UNITED STATES PATENT AND TRADEMARK OFFICE

APPLICATION NO.	FILING DATE	FIRST NAMED INVENTOR	ATTORNEY DOCKET NO.	CONFIRMATION NO.
10/068,239	02/05/2002	Terrence John O'Neill	77017-9005-01	7695
23409	7590	05/16/2006	EXAMINER	
MICHAEL BEST & FRIEDRICH, LLP 100 E WISCONSIN AVENUE MILWAUKEE, WI 53202			GOODWIN, JEANNE M	
			ART UNIT	PAPER NUMBER
			2841

Office Action Summary	Application No.		Applicant(s)	
	10/068,239		O'NEILL, TERRENCE JOHN	
	Examiner		Art Unit	
	Jeanne-Marguerite Goodwin		2841

DETAILED ACTION

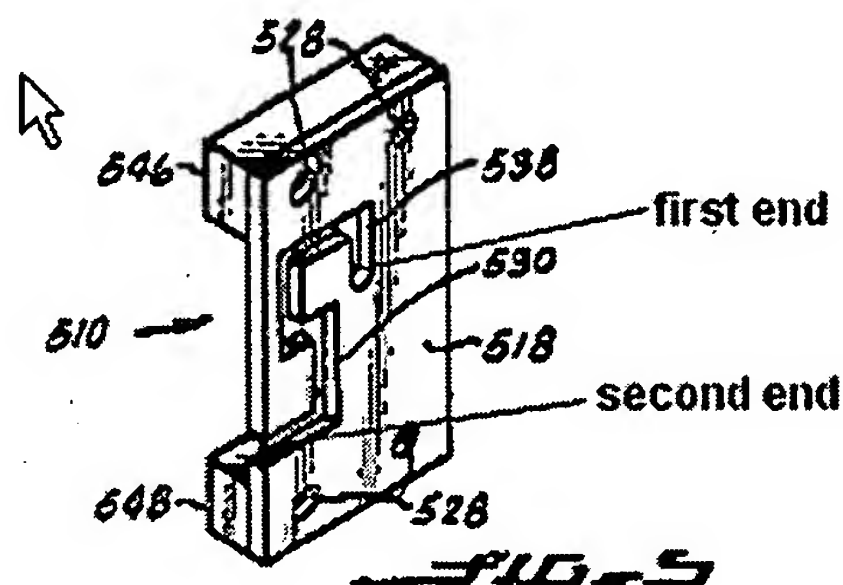
hanger comprising a housing having a face positioned substantially vertically; and a nonlinear slot cut into the face, the slot having a first end and a second end, the first end being closed and the second end being opened (see figure below).

With respect to claim 2: Based upon the Applicant's figures, Updike's discloses a hanger, wherein the hanger includes a protrusion movable along the slot, wherein movement of the protrusion along the slot from the second end toward the first end is substantially unimpeded, and wherein during movement of the protrusion along the slot from the first end toward the second end, the protrusion is selectively movable along the slot branches slot branches to impede movement of the protrusion along the slot toward the first end (see figure above).

With respect to claim 3: Updike's slot has a substantially constant width (see figure above).

With respect to claim 4: Updike's slot makes at least one change of direction of greater than 45 degrees (see figure above).

the receiving area, and at least one substantially vertical slot branch extending from the slot at an acute angle and having a closed end, the at least one slot branch having a substantially constant width that is substantially the same as the width of the slot (see figure above).

FIG. 4

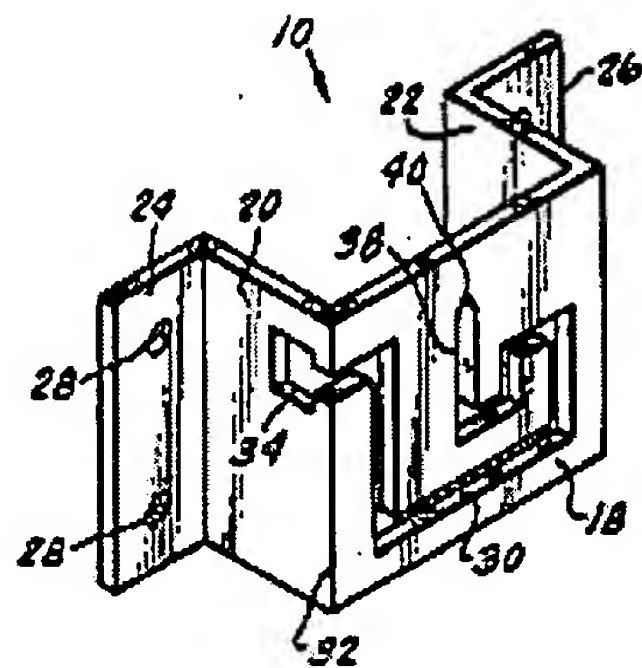
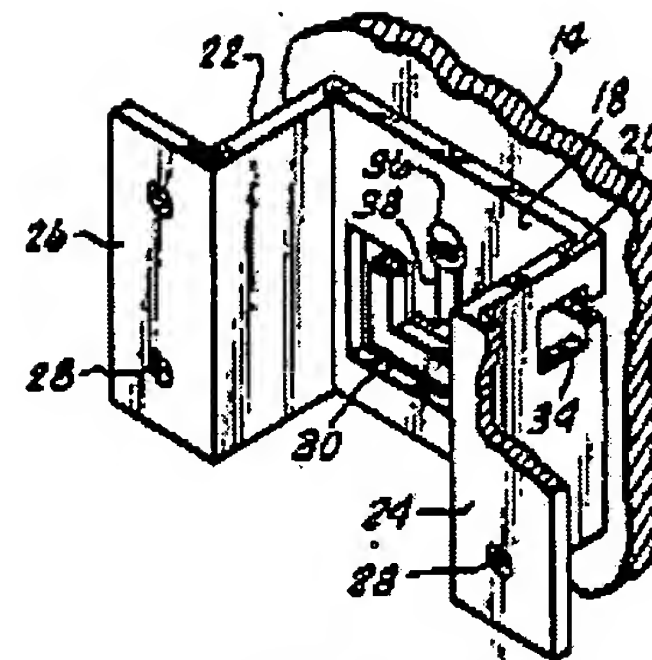
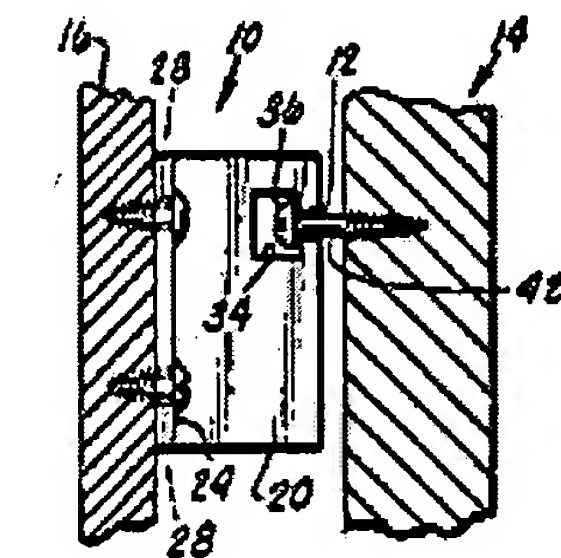
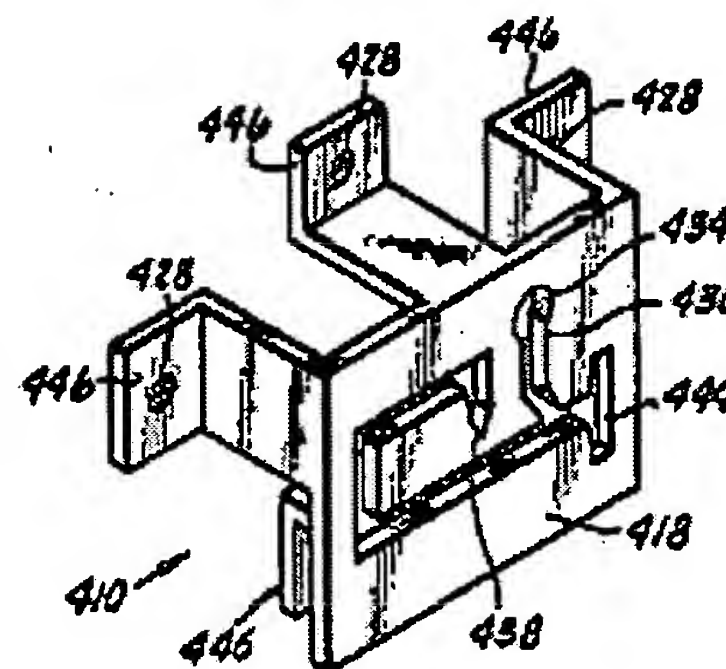
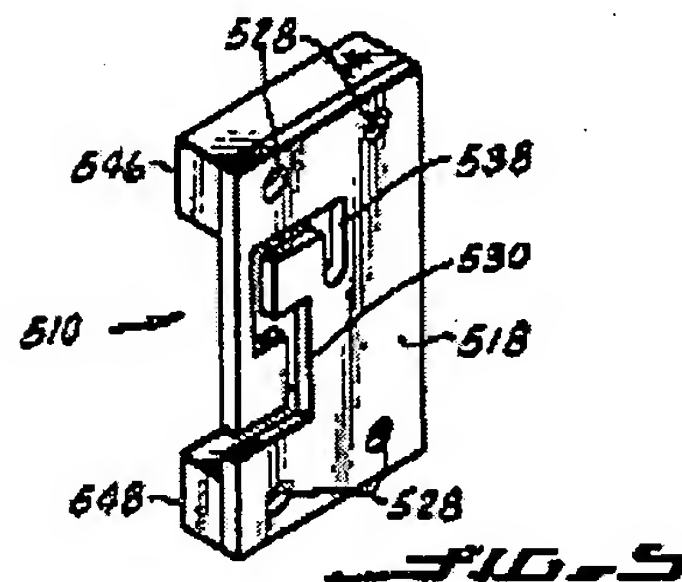
With respect to claim 19: Updike discloses a hanger for supporting a device (picture frame 16) on a projection extending outwardly from a wall, the hanger comprising: a housing having a hanger face, the hanger face defining a substantially planar hanger face surface; and a nonlinear slot extending into the hanger face and lying in the planar hanger face surface and being engageable with the projection to secure the device to the wall, the slot defining an entry

path for the projection, an exit path for the projection, and at least one locking path for the projection, the locking path being different than the exit path (see figures above).

With respect to claim 20: Updike discloses the hanger of claim 19, wherein, when the projection is located in the locking path, the device is lockingly secured to the wall (see figures above).

With respect to claim 21: Updike discloses the hanger of claim 19, wherein the hanger face defines a substantially vertical plane, and wherein the slot lies in the substantially vertical plane (see figures above).

With respect to claim 22: Updike discloses the hanger of claim 21, wherein the projection includes a head portion, and wherein, when the projection is located in the nonlinear slot, the head portion engages a back surface of the hanger face, preventing movement of the device away from the wall in a direction substantially perpendicular to the substantially vertical plane (see figures above).

With respect to claim 23: Updike discloses the hanger of claim 19, wherein the slot has substantially constant width (see figures above).

With respect to the claim 24: Updike discloses the hanger of claim 19, wherein the slot includes a first and a second end, the first end being closed and the second end opening into a receiving area, and wherein the receiving area appears to be at least twice as wide as the slot (see figures above).

With respect to claim 25: Updike discloses the hanger of claim 24, wherein the slot makes at least one change of direction of greater than 45 degrees between the first end and the second end (see figures above).

With respect to claim 26: Updike discloses the hanger of claim 19, wherein the slot includes an opened end, a first closed end, and a second closed end, and wherein the locking path extends between the first closed end and the second closed end (see figures above).

With respect to claim 27: Updike discloses the hanger of claim 26, wherein the exit path extends between the first closed end and the opened end, and wherein the entry path extends between the opened end and the first closed end (see figures above).

With respect to claim 28: Updike discloses the hanger of claim 19, wherein the exit path includes at least one change of direction along the nonlinear slot (see figures above).

With respect to claim 29: Updike discloses the hanger of claim 28, wherein the change of direction is at least about 45 degrees (see figures above).

With respect to claim 30: Updike discloses the hanger of claim 19, wherein at least a portion of the locking path defines an acute angle with respect to at least a portion of the exit path (see figures above).

a different embodiment, Fig. 4, a slot including a third, closed end and wherein the locking path extends between the first, closed end and the third, closed end. Therefore, it would have been obvious to a person having ordinary skill in the art at the time the invention was made to add the third, closed end, and wherein the locking path extends between the first, closed end and the third, closed end, of Fig. 4, as taught by Updike, to the housing assembly of Fig. 1, as taught by Updike, in order to further confuse an unauthorized person attempting to remove an object attached with the hanger, as already suggested by Updike.

belief, the prior art of record, i.e., Updike, does in fact disclose in another embodiment, Fig. 4, slot branches/blind branch diverging from the slot and terminating in closed ends (col. 4, lines 3-10).
